STAFF RECOMMENDATION
224 Lauderdale Road
May 21, 2014

Application: Demolition—principal building; New construction-infill and outbuilding
District: Cherokee Park Neighborhood Conservation Zoning Overlay
Council District: 24
Map and Parcel Number: 10312012900
Applicant: Stewart Bronson, Stone Oak Builders, LLC
Project Lead: Paul Hoffman, paul.hoffman@nashville.gov

<p>Description of Project: The application is to demolish a non-contributing primary structure and to build a new single-family residence and detached garage.</p> <p>Recommendation Summary: Staff recommends approval of the project with the conditions:</p> <ul style="list-style-type: none"> • Staff approve masonry samples, windows, doors, garage doors and color of roofing material; • A front walkway be constructed from the new house to the street; and, • HVAC be located on a rear façade, or on a side façade beyond the midpoint of the house. <p>With these conditions, Staff finds that the project meets sections II.B and III.B of the Cherokee Park Neighborhood Conservation Zoning Overlay Design Guidelines.</p>	<p>Attachments A: Photographs B: Site Plan C: Elevations</p>
--	--

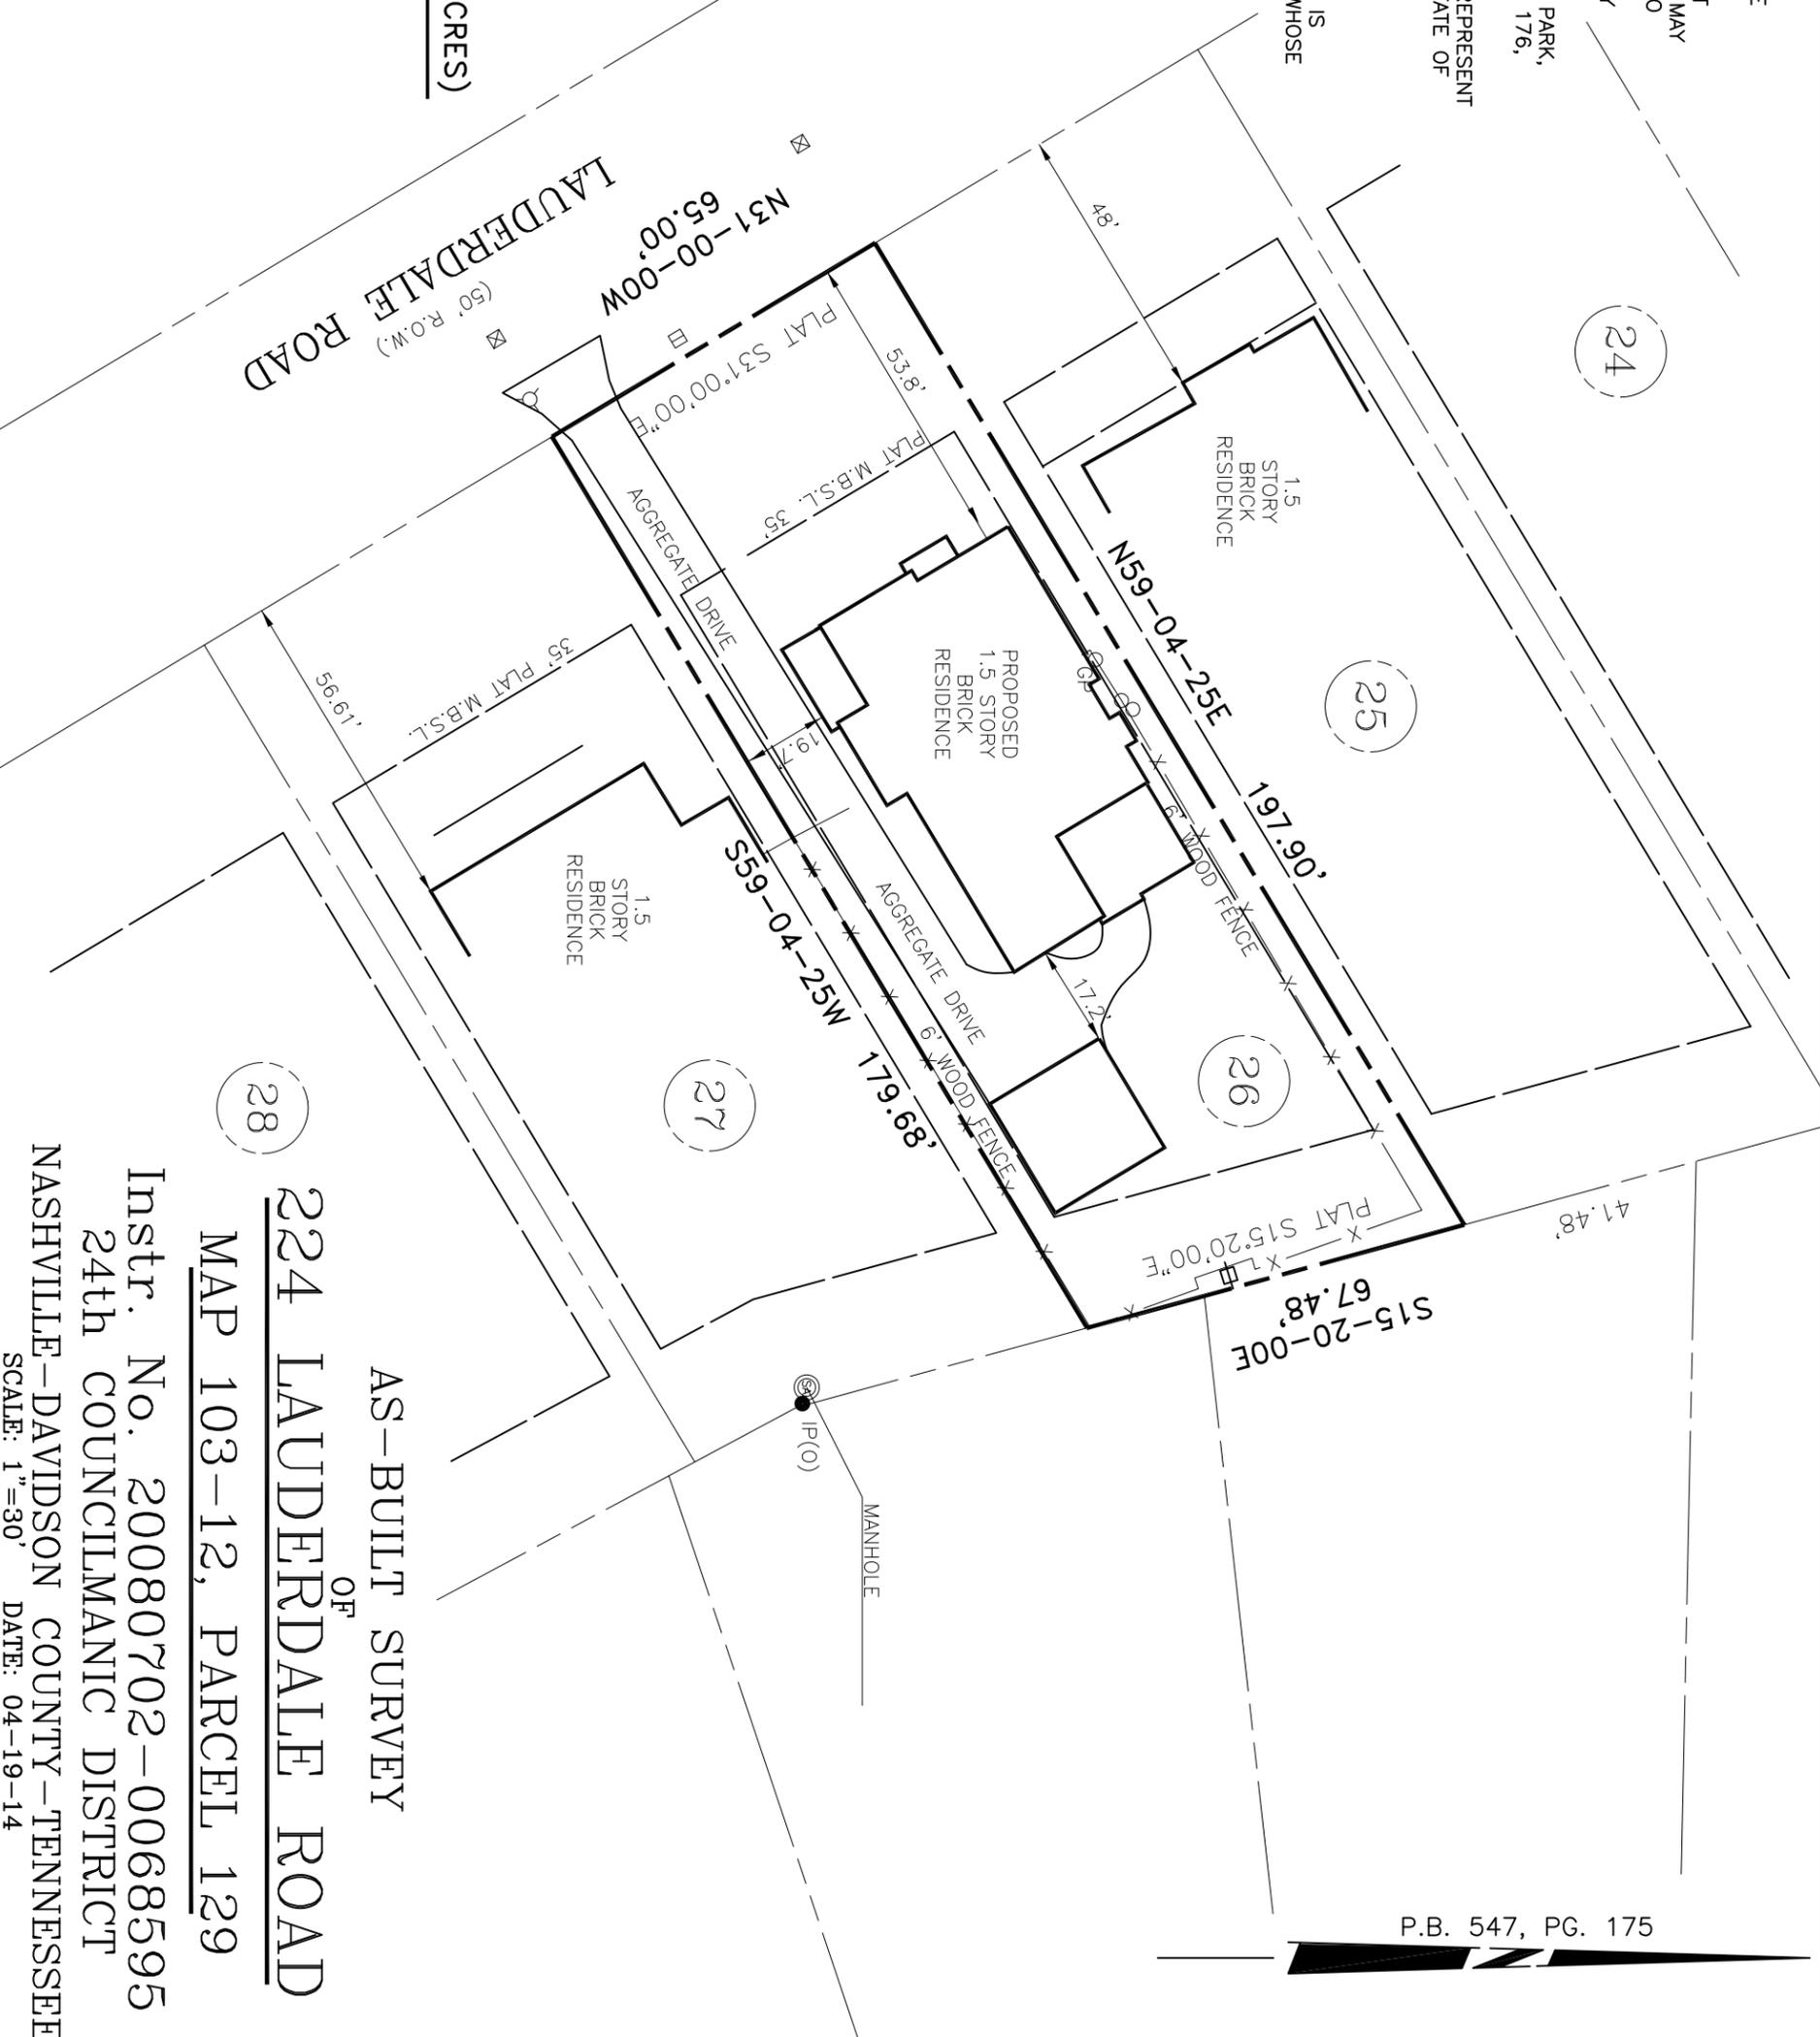
Setback & Rhythm of Spacing: The new building has a front setback of fifty-three feet nine inches (53'9"), which is midway between the adjacent contributing buildings. The lot is sixty-five feet (65') wide. Side setbacks of five feet (5') and nineteen feet (19') and rear setback of forty-five feet (45') meet base setback requirements. An existing driveway will be continued past the new house to the proposed garage. Staff finds the project's setback and rhythm of spacing meets section II.B.1.c.

Orientation: The house has a central entrance facing Lauderdale Road. The proposal includes a driveway on the site of the existing one, but not a walkway. Staff requests a walkway to the street, in keeping with the context. There is no rear alley for vehicular access and the driveway is in keeping with the context. Staff finds the project meets section II.B.1.f.

Appurtenances & Utilities: A driveway on the site of the existing one will connect the street to the new outbuilding. A six-foot wood fence will be built from the midpoint of the house around the rear of the yard. The location of the HVAC and other utilities was not noted. Staff asks that the HVAC be located on the rear façade, or on a side façade beyond the midpoint of the house. The project meets section II.B.1. i.

- Staff approve masonry samples, windows, doors, garage doors and color of roofing materials;
- A front walkway be constructed from the new house to the street;
- HVAC be located on a rear façade, or on a side façade beyond the midpoint of the house.

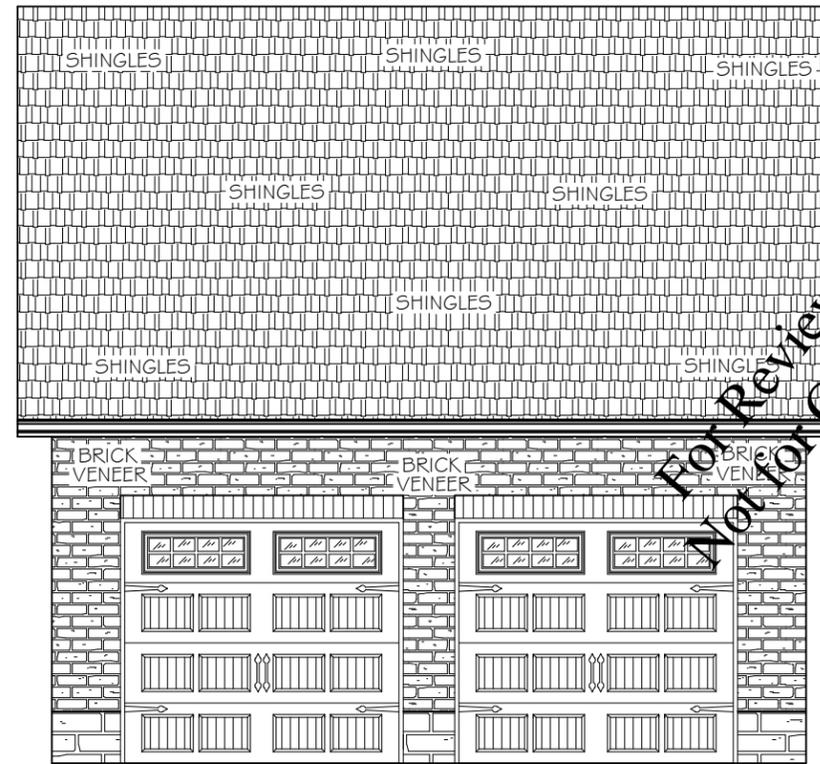
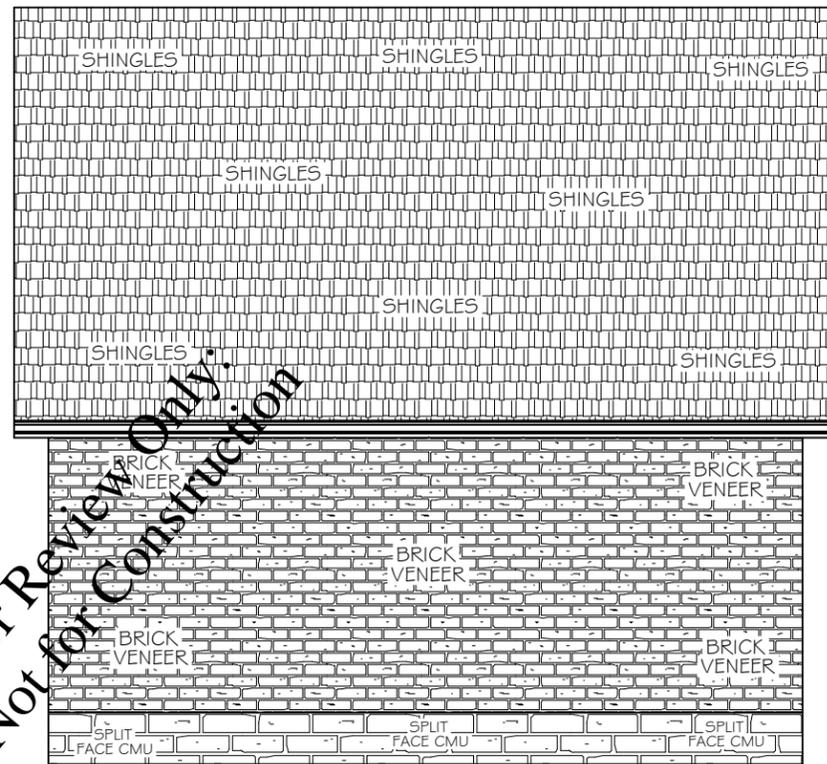
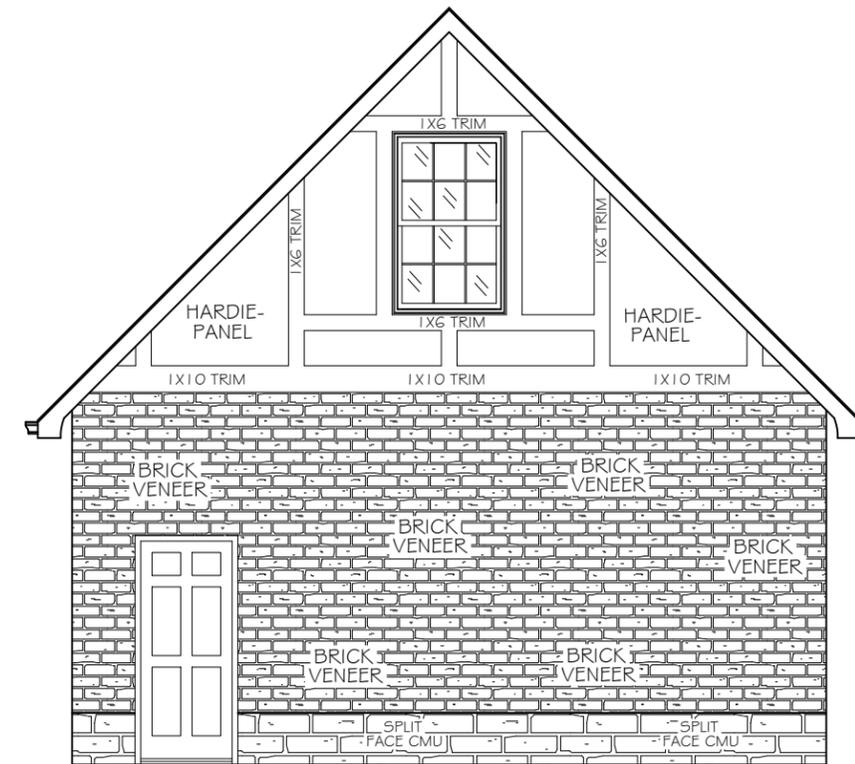
Outbuildings: The application includes a one-and-a-half story garage. It measures approximately twenty-one feet (21') square for a footprint of four hundred and forty-one square feet (441 sq. ft.). The eave height will be nine feet (9') from grade and the ridge height will be twenty-one feet (21'). This is subordinate to the house, which as stated earlier will be approximately thirty-two feet (32'). The garage doors will face Lauderdale Road. The outbuilding will be located to the right of the primary building, five feet (5') from the side and twenty feet (20') from the rear, and meets setback requirements of three feet (3') on both the side and rear. The house next door and many others in the neighborhood have an outbuilding in a similar location. The project meets section II.B.1.h.2.

The materials for the outbuilding will be split-face concrete block, brick, cement fiber panels, and wood or cement fiber trim. Roofing was not specified. With approval of windows, door and garage doors, brick, and color of roofing material, Staff finds the project meets section II.B.1.h.1 of the design guidelines.
